**DEVIATION REQUEST  
AND DECISION FORM**  
( Judge Orr Deviation )  
Updated: 6/26/2019

Project Name : Monument Ridge East  
Schedule No.(s) : 7102200013, 7102200006, 7102200010  
Legal Description : TRACT OF LAND IN N2 SEC 02-11-67 DESC AS FOLS, COM AT NE COR OF SD SEC, TH S 89<06'54"  
W 1320.00 FT, S 00<53'12" W 30.00 FT FOR POB, TH S 89<06'54" W 1834.51 FT TO PT ON ELY R/W LN  
OF I25, TH ALG SD R/W S 29<33'00" W 180.19 FT, S 89<05'00" W 500.00 FT, S 29<16'30" W 675.30 FT,  
S 06<43'00" W 36.92 FT, S 89<57'36" E 251.71 FT, S 06<43'00" W 337.98 FT, S 89<57'36" E 732.00 FT,  
TH N 14<12'38" E 887.45 FT, N 89<06'34" E 500.0 FT M/L, N 00<02'24" W 270.0 FT, S 89<06'54" W 650.0  
FT M/L TO POB, EX PT DES AS FOLS: TR OF LAND IN NW4 SEC 2-11-67 DES AS FOLS: COM AT NE  
COR OF SD SEC 2, TH S 89<06'54" W ALG N LN OF SEC 2 A DIST OF 2879.42 FT, TH ON A  
DEFLECTION ANGLE TO THE L OF 90<00'00" 50.00 FT TO A PT 20.00 FT S OF EXISTING SLY R/W LN  
OF COUNTY LINE RD FOR POB, TH N 89<06'54" E 105.00 FT, S 13<48'06" W 130.00 FT, S 89<06'54" W

A deviation from the standards of or in Sections **2.2.5.C** and **2.3.2** of the Engineering Criteria Manual (ECM) is requested.

Deviation No. 2 - Ex

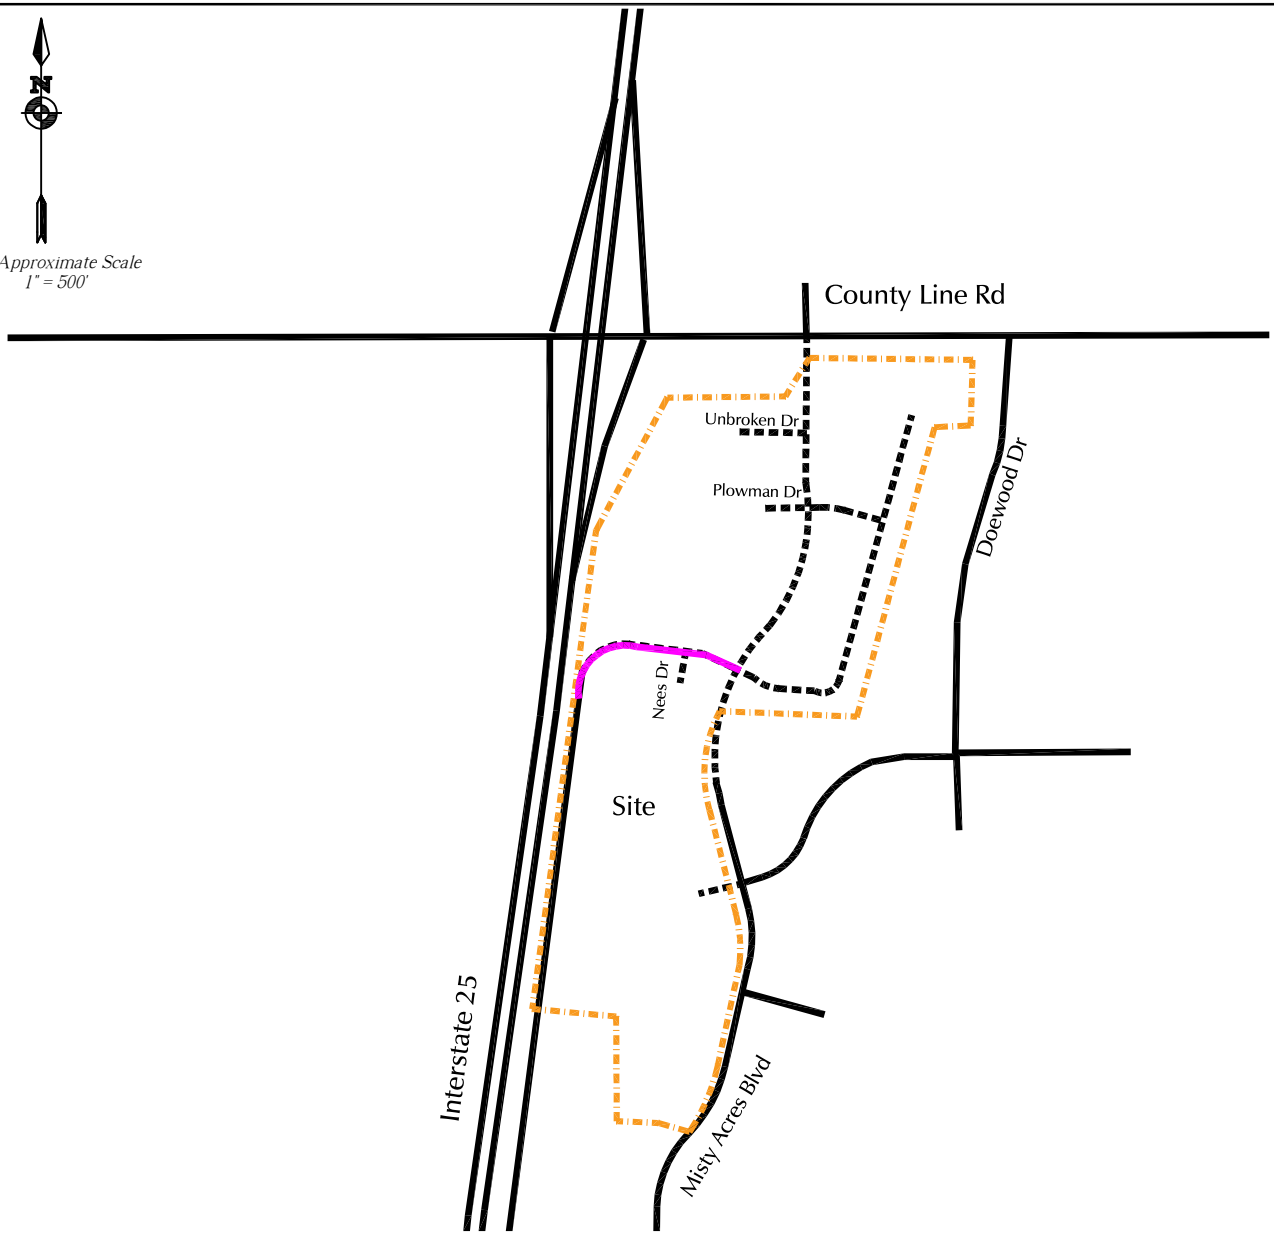
Please clarify if this section is included in this deviation; access does not appear to be the correct section
